# Exhibit E

Subject: Review of Applicant Noncompliance with Conditions of Approval  
Marketplace Redevelopment Project  
Planned Unit Development/Preliminary Development Plan  
Shellmound Street: 6340 & 6390 Christie Avenue  
File Number: PUD 04-02  
Exhibit A. Conditions of Approval, August 5, 2008

This letter is a summary of my review of the Emeryville Public Market, Parcel B, Final Development Plan, January 9, 2019 provided by City Center Realty Partners and approved by the City Planning Commission on May 14, 2019. Chapter 5 Urban Design, of the Emeryville General Plan focuses on enhancing the public realm and everyday livability, crafting a tapestry of distinctive, yet synergistic and connected districts, and strengthening Emeryville's identity and sense of place. It includes narratives, images and diagrams that provide clear guidelines for the design and development community to incorporate into their projects, with the intention of preventing negative impacts to the environment and urban fabric of the City of Emeryville. The Conditions of Approval, California Environmental Quality Act, and the goals and policies that detail compliance strategies are key tenets of the Genera

FDP Massing FDP 18-001r

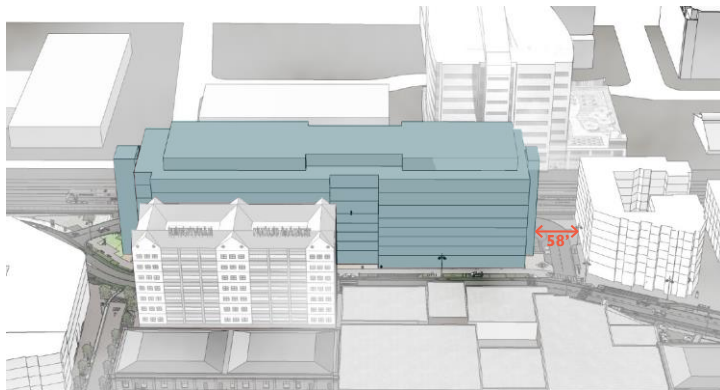
The April 25, 2019 Planning Commission Staff Report states that although the proposed FDP for Parcel B would contain 30,000 square feet more area and 42 more parking spaces compared to the approved PUD/PDP, the overall intensity of the PUD build-out would be less than allowed by the PDP. While true for the overall PDP the density of Parcel B needs to be viewed alone, in which case it is larger than allowed. Further, it ignores the physical impacts that are the result of these changes, and the failure to comply with the PDP Conditions of Approval mitigation measures.

The massing changes triggered by the additional Commercial Laboratory space and additional parking count in the FDP for Parcel B in January are significantly different from, and inconsistent with the PDP and have a severe negative impact on the scale of the neighborhood and the environmental impacts associated with Parcel B.

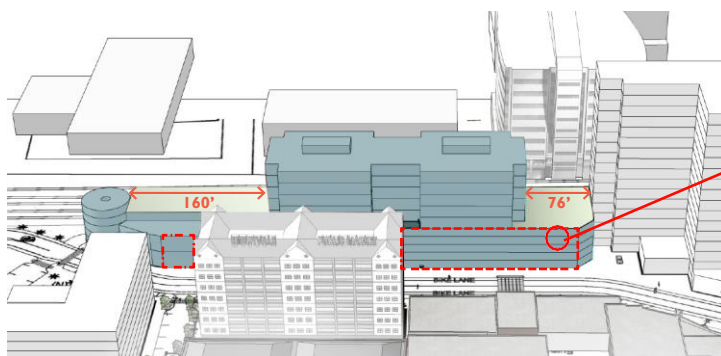
The proposed structure does not adequately reference and is not visually compatible with surrounding existing industrial buildings, or approved mixed use buildings on Parcels A, C and D. The Public Market is a 1-2 story masonry industrial adaptive re-use project that succeeds and sets a precedent for the type of reference that is appropriate for the area. Parcel B does not take any cues from industrial buildings in Emeryville. There are great examples of larger scale industrial buildings in Oakland and San Francisco that could bring a much more compatible aesthetic to this neighborhood. This building detracts from the mixed-use projects that surround the Public Market to the North (Parcel C, Parcel D) and the forthcoming Parcel A project, all of which are well designed within the guidelines suggested in the Conditions of Approval. These buildings contribute to a scale that is prevalent in Emeryville.

PDP Massing incorporates stepping, vertical recesses, and inverted corners to mitigate bulk and transitions to adjacent properties

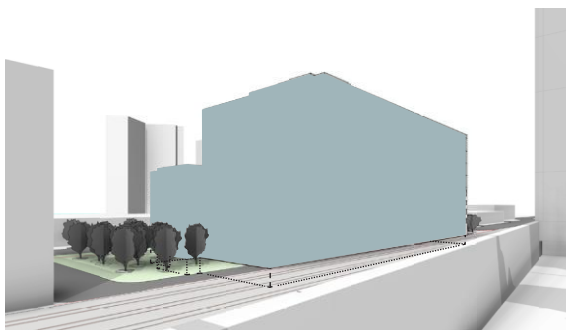
This project lacks vitality, variety and architectural detail. The retail is nominally differentiated from levels above but the lack of variety in massing, and the relentless repetition of same size structural bays creates a monotonous pedestrian experience. The only detail that provides relief is the entrance bays on the West facade, being slightly recessed at the ground floor. This design will negatively impact the streetscape due to the over shadowing height and length of the facade. Variations in the massing proposed are very small in relation to a building this size and do not successfully mitigate the wall like appearance of the building. *The General Plan follows the principle of “stepping down” to lower scale development in the city, as well as stepping back upper floors from the street edge in order to transition between various heights and densities.* The PUD/PDP massing incorporates a clear definition of a street wall at approximately 4 stories that successfully transitions to proposed heights on Parcel A, Parcel C, and Parcel D. This scheme also provides a terrace above the street that could be a public open space and visual relief for building East of Parcel B. This type of space can effectively enhance the pedestrian experience. The current FDP massing does not provide this opportunity. The massing of the tower in the PDP massing also recesses bays, inverts corners and significantly reduces the size of the tower floors. These moves significantly reduce the impact of the massing on the neighborhood. The proposed structure does not incorporate any massing that transitions to adjacent buildings.

Alternate Scheme provides terrace and open space enhancing pedestrian experience

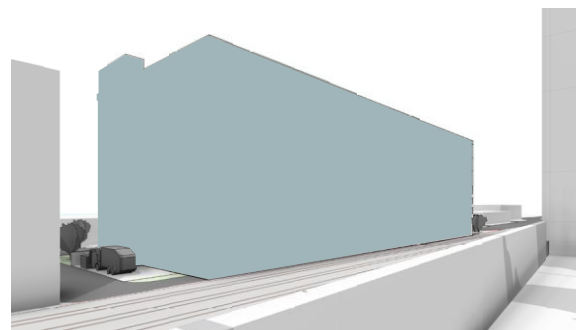
Current design creates visual barrier and a service yard with no public open space

2. 3-D VIEW FROM THENORTHEAST

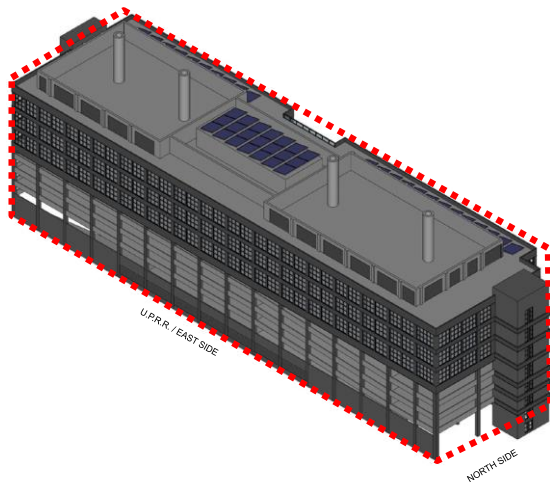
The primary form of this design is a box; 470' long x 122' wide x 113' high. With the exception of a stair/ elevator towers at either end, the massing result of the garage and lab floors above are identical, contributing to an overwhelming box-like form.

Alternatively, it is possible to reduce the tower floor plate sizes and add another level of Lab. Requiring a reduced floor to floor height in the garage and lab floors, this enables an additional Lab level, remaining below the 120' height limit, and significantly reducing the mass of levels above the garage. Many examples exist of Class A Lab space developed with 15' floor to floor height, including Wareham's recently completed project to the East (where slab to slab heights are actually 14'-10"). This alternative would be compliant with the Conditions of Approval, breaking the box-like form into a massing strategy that transitions to neighboring buildings, and delivers the same area requirements as the existing Parcel B design. The General Plan seeks building form *to be articulated to create visual interest, prevent bulky structures, and avoid blank walls.*

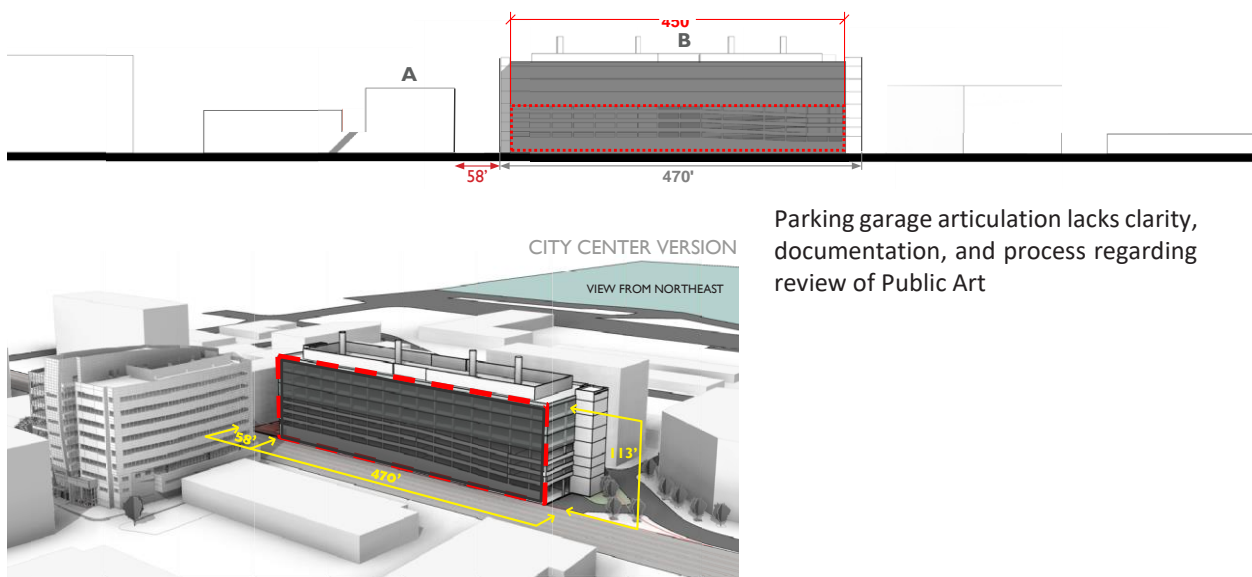
The overall length and height of this design visually segregates the Emeryville Public Market from the Amtrak Station and all development east of the railroad tracks. There are no variations in building planes on the east façade of this building. There are no apparent significant changes in the depth of the wall. The metal panel is practically flush to the window frame and the glass is only a few inches back from the face of the frame/ metal panel. This means there will be little if any modulation of light and shadow that help to articulate an apparent scale that can be referenced to other buildings. There are no balconies or trellis like elements that break down the scale of the East façade. The design creates a 450' long visual wall with no articulations in the massing to blend in with the urban fabric of the neighborhood.

The design lacks articulation that diminishes or modulates the massive scale of the East and west Facades. Although there is a slight recess at one location on the West facade, the lack of details that bring shadows and modulate the relentless order prohibits relationships that bring scale to the neighborhood. Each façade incorporates the same frame and window system, and same dark color palette with the only exception being the entry bay on the West. There is no articulation that responds to the existing scale of the neighborhood. While the concept of incorporating Public Art into the parking garage presented by the applicant appears to mitigate the lack of detail and lack of craft associated with parking structures of this type, the documentation that supports it is vague. The Conditions of Approval also lack specificity regarding the public review of the Public Art. The area associated with Public Art is approximately 50% of the East and West facades. Clearly the scope and budget for these treatments needs to be communicated. Simply painting the crash walls will not achieve the adornment and articulation required to conform to the Conditions of Approval.
